Newtex Design Ltd. (9514)
Impress-Newtex Composite Textiles Ltd. (10256)
Newtex Knit Fashion Ltd. (11724)

Gorai, Industrial Area, Mirzapur, Tangail
(+ 24.089332N, 90.171028E)

14.MAY.2014

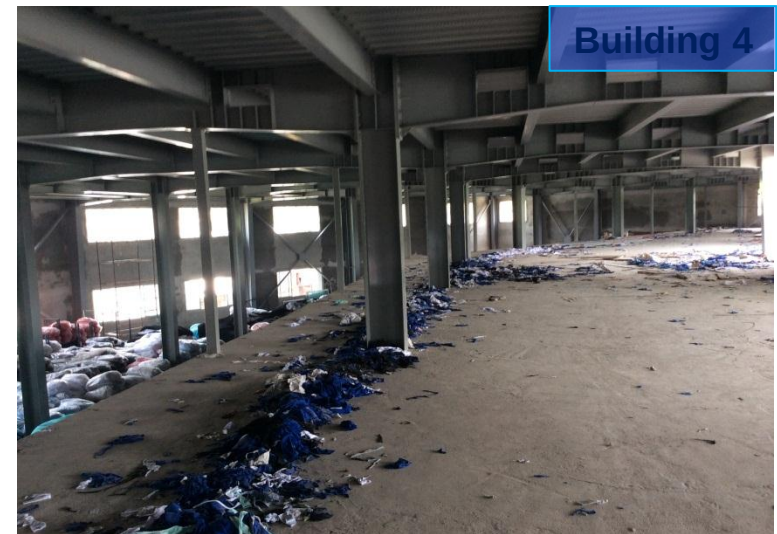
However according to material property, the yield strength of steel (F_y) is 34.5 kN/sq.cm. But, for the purposes of this report, we have continued to use the yield strength of steel (F_y) of 25.2 kN/sq.cm. The decision whether to adopt the values from the materials specifications is left to the Detailed Engineering Assessment.

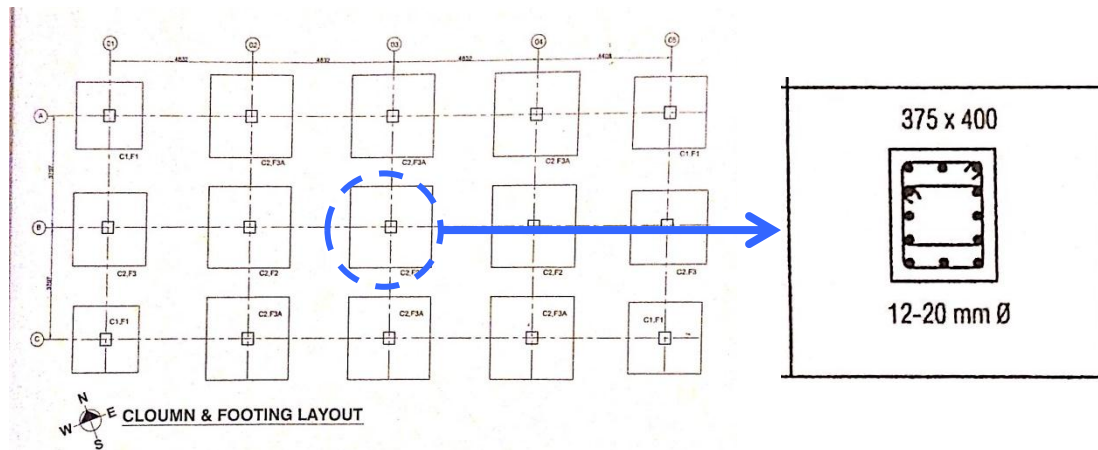
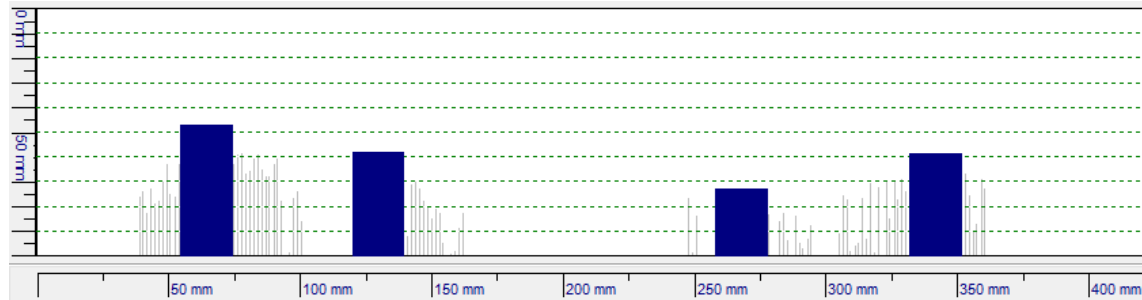
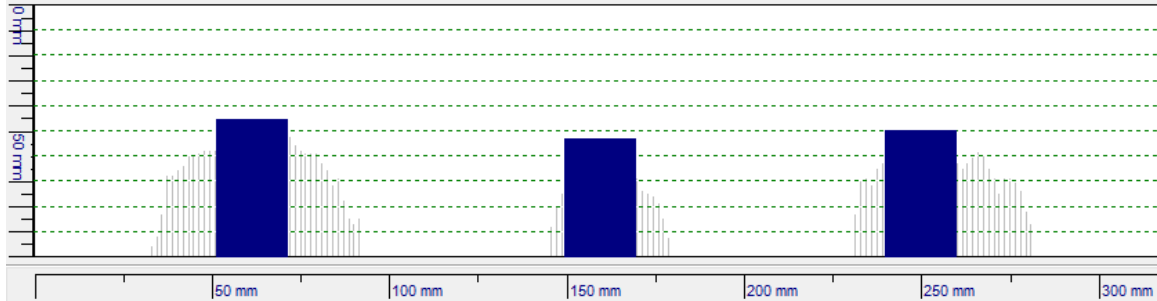
Identified Priority 2 Concerns

- No fireproofing for steel structure elements,
- Inconsistencies between the drawings of Building 2 and the actual as-built conditions

It is unclear whether fire proofing material is applied on structural steel elements.

The size of column C2, as measured at the ground floor (300 x 350 mm) is smaller than what is specified in the drawings (375 x 400 mm). The no. vertical rebar measured on-site (10-Ø20 mm) is less than what is specified in the drawings (12-Ø20 mm).

From calculation check, it indicates that the FoS of interior column is 4.79.

Overall Stability System

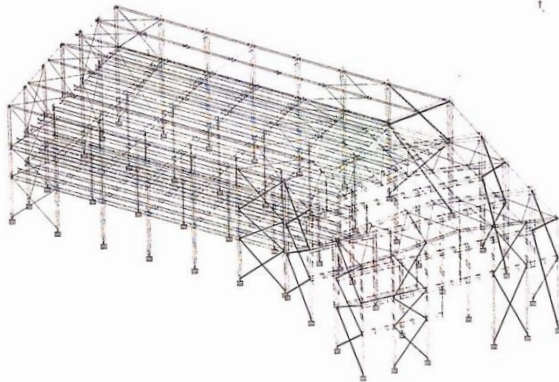
We were informed that lateral load was included in the design of Building 4 as shown in the graphic output below, submitted by .

However there are concerns on the stability system for lateral loading and seismic loading of Building 1, Building 2 and Building 3.

We require that these items be investigated in a Detail Engineering Assessment.
